Product Change Notice

RER120-26/14/2 TDP

9594314001

**Werte bisher /
current design**

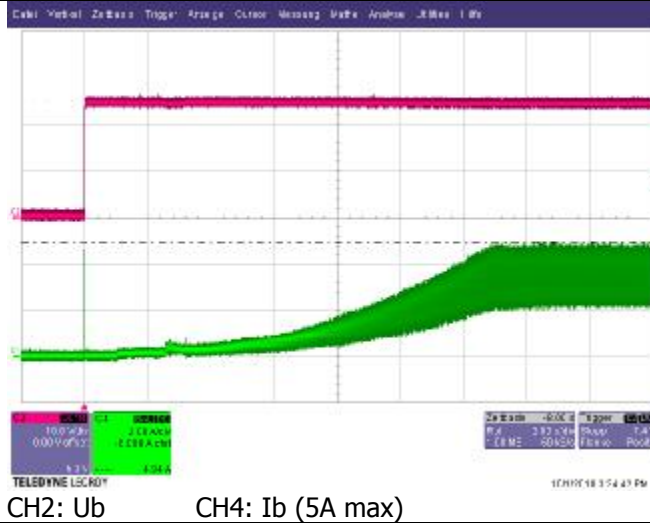
startup:

CH2: Ub CH4: Ib (5A max)

**Werte neu /
adapted Design**

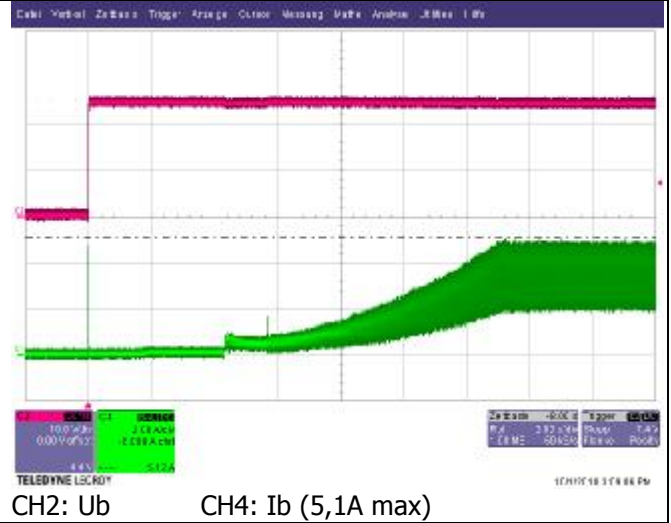
CH2: Ub CH4: Ib (5,1A max)

locked Rotor:

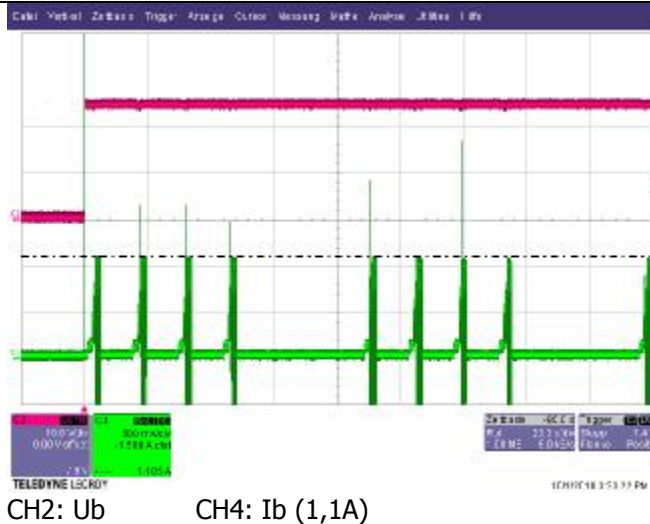
CH2: Ub CH4: Ib (1,1A)

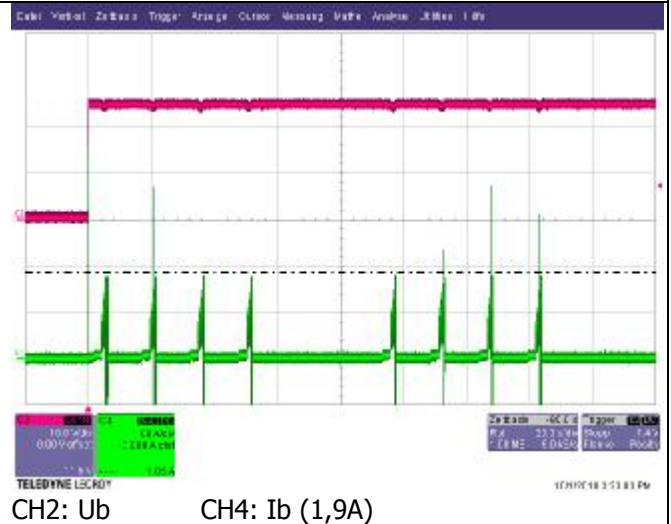
CH2: Ub CH4: Ib (1,9A)
